# SIEMENS

AK 1703 ACP

Instruction

Switching from CP-2010 to CP-2014

### 3.6.) Fitting Connection Board with Patch Plugs(wenn Anschlussplatine CM-2837 auf CP-2010 bestückt war)

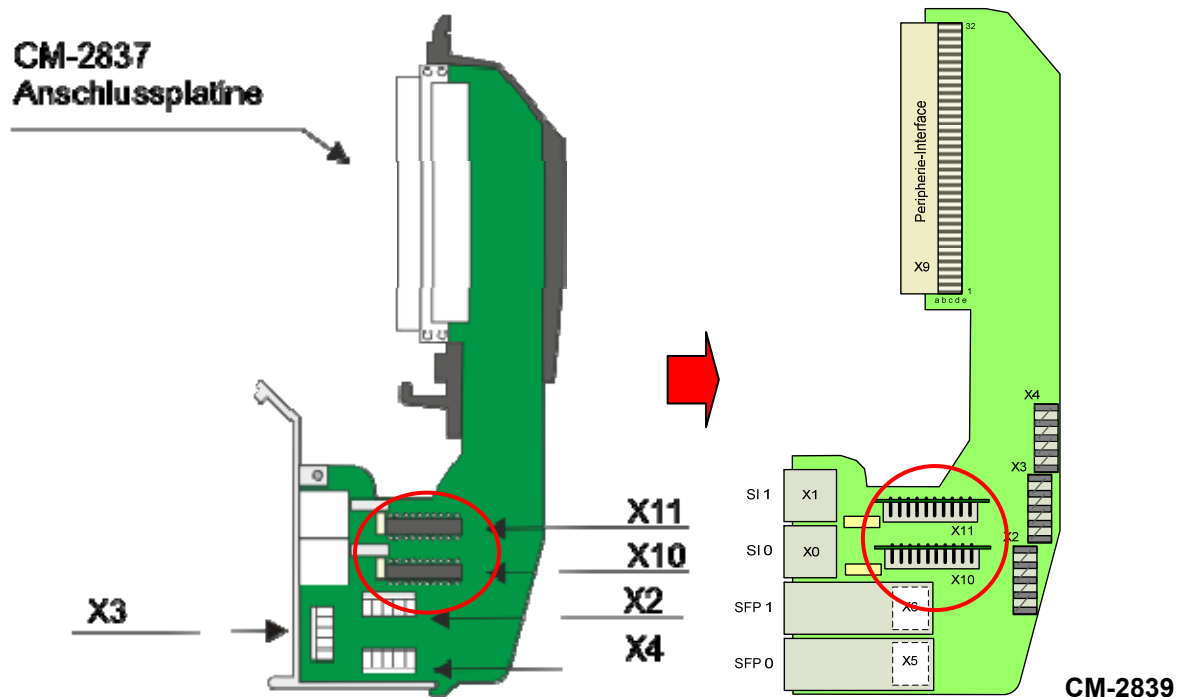
Unplug the Patch Plugs from the sockets of the CM-2837, and plug them into the respective socket connector (X11, X12) of the CM-2839.

### 3.7.) Wiring for Reception of Time Signals, Watchdog and Error (if CM-2837 was mounted on CP-2010)

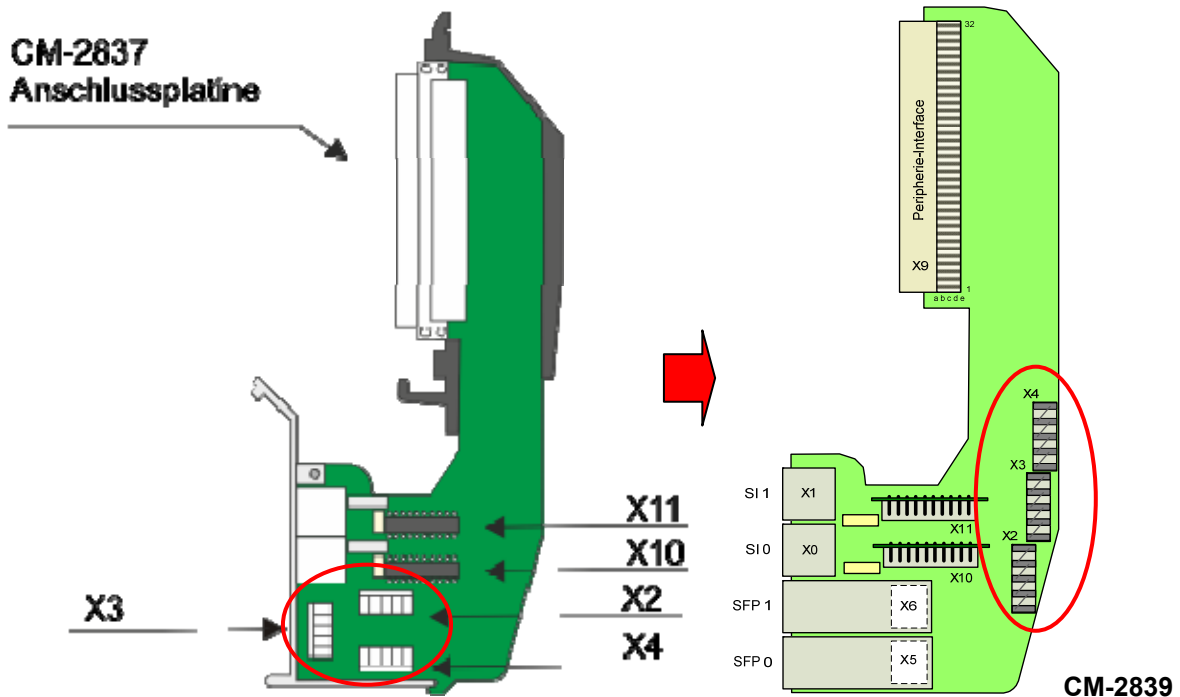
For wiring proceed as described in installation manual AK 1703 ACP (HB AK 1703 ACP Installation (e))  
Only the position of the connectors X2, X3, X4 was changed.
